RESOLUTION SETTING HEARING ON APPEAL BY PENTA PARTNERS, LLC OF THE CONDITIONS OF A SITE PLAN FOR PROPERTY LOCATED AT 2544 HUBBELL AVENUE

Communication from the City Plan and Zoning Commission advising that at their April 5, 2018 meeting, the following action was taken regarding a request from Penta Partners, LLC (owner) represented by Travis Sisson (officer) for review and approval of a Site Plan "Classic Autoworx Site Improvements" under design guidelines for vehicle display lots on property located at 2544 Hubbell Avenue, to allow the property to be used for vehicle sales.

Penta Partners, LLC, Classic Autoworx Site Improvements, 2544 Hubbell Avenue

SITE PLAN FOR: CLASSIC AUTOWORX SITE IMPROVEMENTS

SITE PLAN

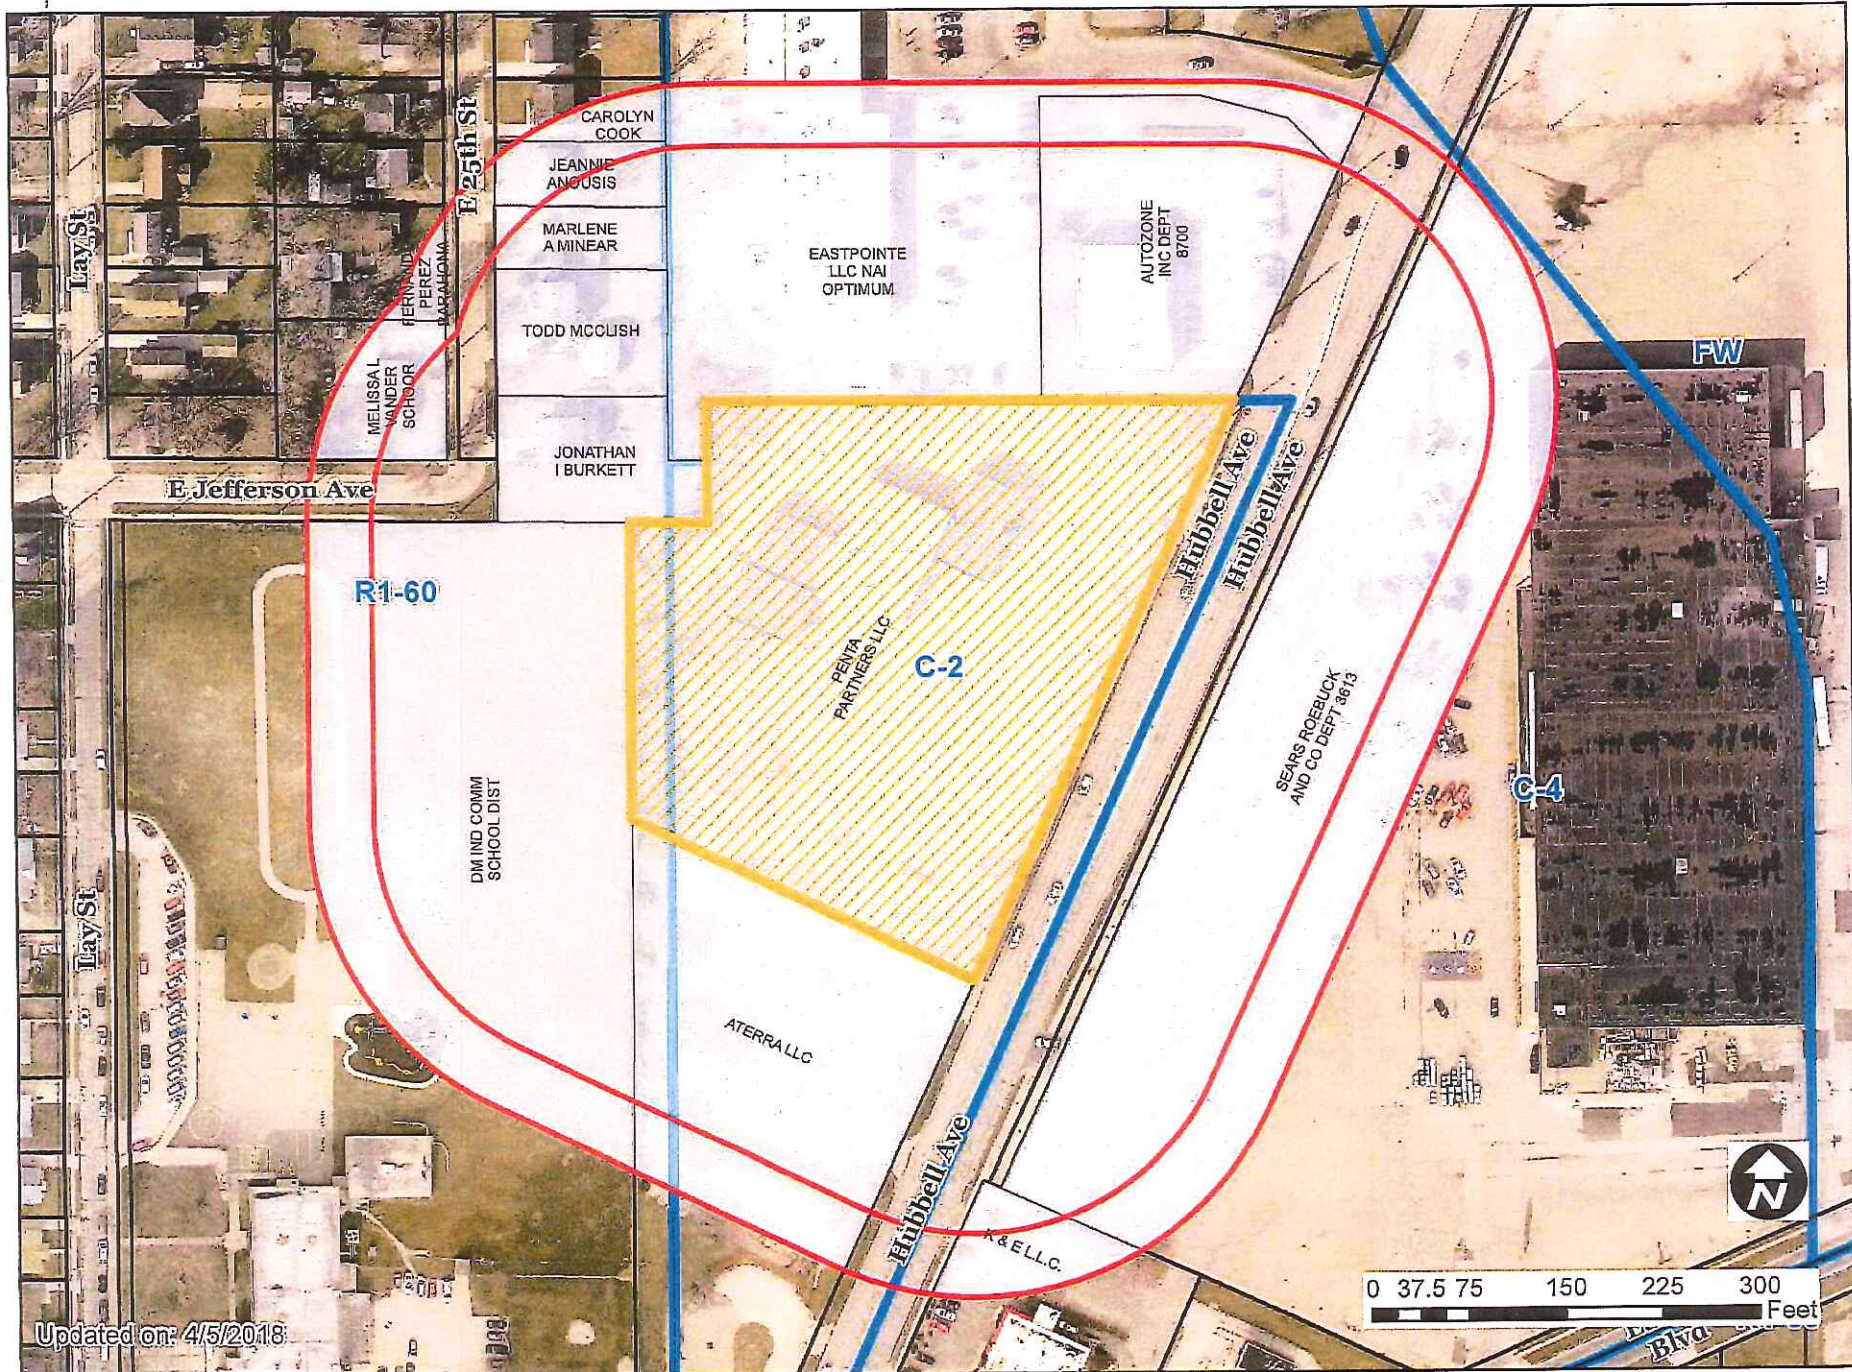
2. Provision of a 20-foot paving setback along the western property line adjoining an "R" District.
3. Provision of a 20-foot paving setback from the front property line along Hubbell Avenue.

9. The two internal access drives to the property to the south shall be removed and curbing in these areas shall be restored.
10. Provision of a 30-foot wide sanitary sewer easement centered on the north/south sewer within the western portion of the property.

11. Revise note on Site Plan to specify all pole mounted lighting shall have a maximum 20-foot pole height. (10-2018-7.36)

The proposed Site Plan does not provide the minimum required 20% open space requirement or provide the minimum 20 feet of paving setback required from an "R" Residential District. The Site Plan provides 15% open space and a 10-foot paving setback from the "R" District to west. Staff believes that removing pavement in order to provide a 20-foot paving setback is reasonably necessary to protect the adjoining school and residential uses. Furthermore, removing pavement would help the Site Plan achieve the minimum required 20% open space.

- 1. Landscaping and Buffering:** As noted above, the Site Plan does not comply with the City's Landscape Standards with regards to minimum required open space, minimum required buffer yard, minimum interior lot plantings, and screening. Staff believes that is necessary to comply with the Landscape Standards to protect the adjoining school and residential uses.
- 2. Traffic/Street System:** The proposed Site Plan does not alter the existing one (1) drive approach from Hubbell Avenue. However, it demonstrates retention of the two internal access drives to the property to the south. Staff recommends that these be removed and that curbing in these areas must be restored in order to prevent vehicles from encroaching into this area.

3. **Utilities:** There is an existing City of Des Moines-owned 10-inch sanitary sewer running north/south across this western portion of this parcel. A 30-foot wide sanitary sewer easement centered on this sewer should be provided. This existing sewer must be protected during any construction activities and maintenance access must be provided at all times.
4. **Additional Information:** The Site Plan demonstrates that refuse collection containers would be screened by an enclosure located near the northwest corner of the site.

CLASSIC AUTOWORX SITE IMPROVEMENTS LANDSCAPE PLAN

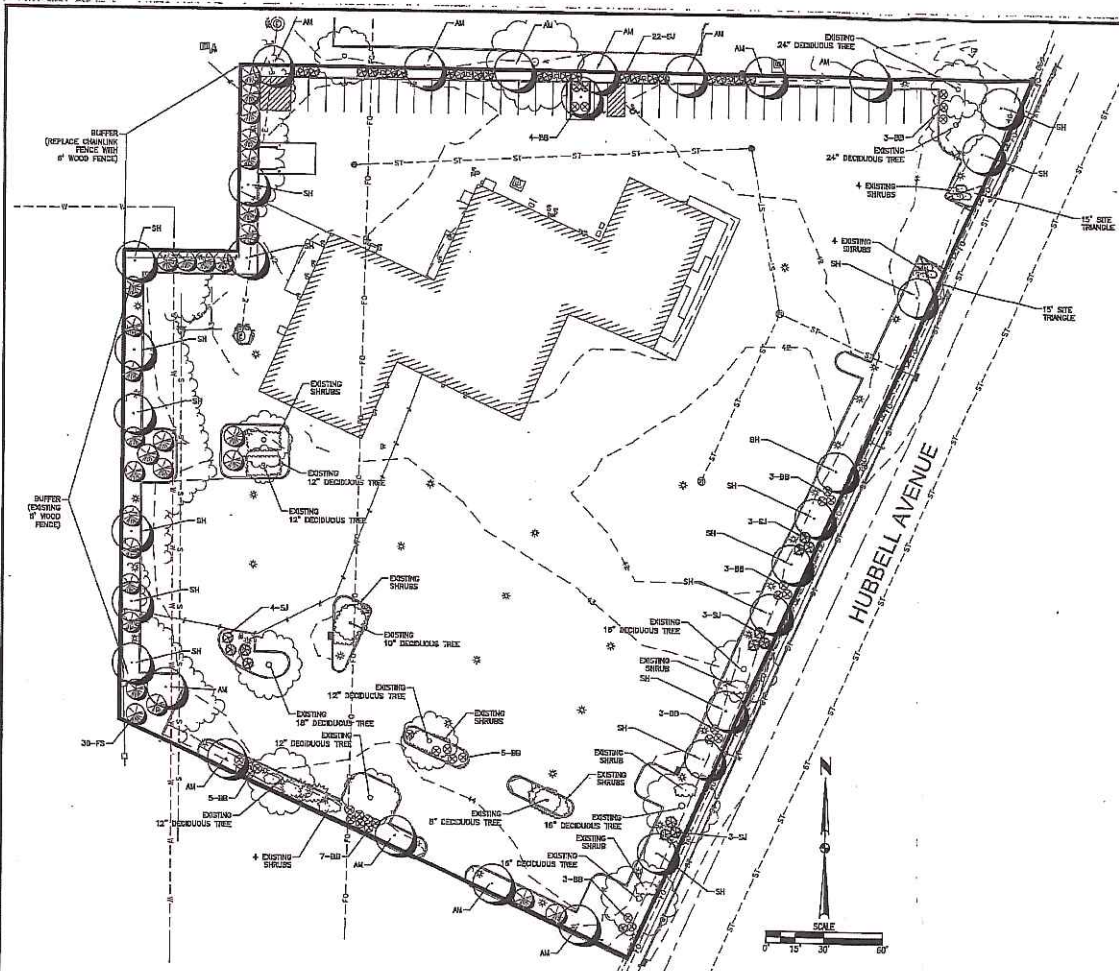
4. Provision of interior parking landscaping that complies with the City's Landscape Standards.
5. Provision of a minimum required 6-foot tall opaque screen along all adjoining "R" Districts.

The proposed Site Plan does not comply with the City's Landscape Standards with regards to minimum required open space, minimum required buffer yard, minimum interior lot plantings, and screening. Staff believes that is necessary to comply with the Landscape Standards to protect the adjoining school and residential uses. The Site Plan should provide 20-foot paving setbacks along the western property line adjoining an "R" District and along the front property line along Hubbell Avenue. The Site Plan must also comply with the interior parking lot standards and provides the minimum required screening.
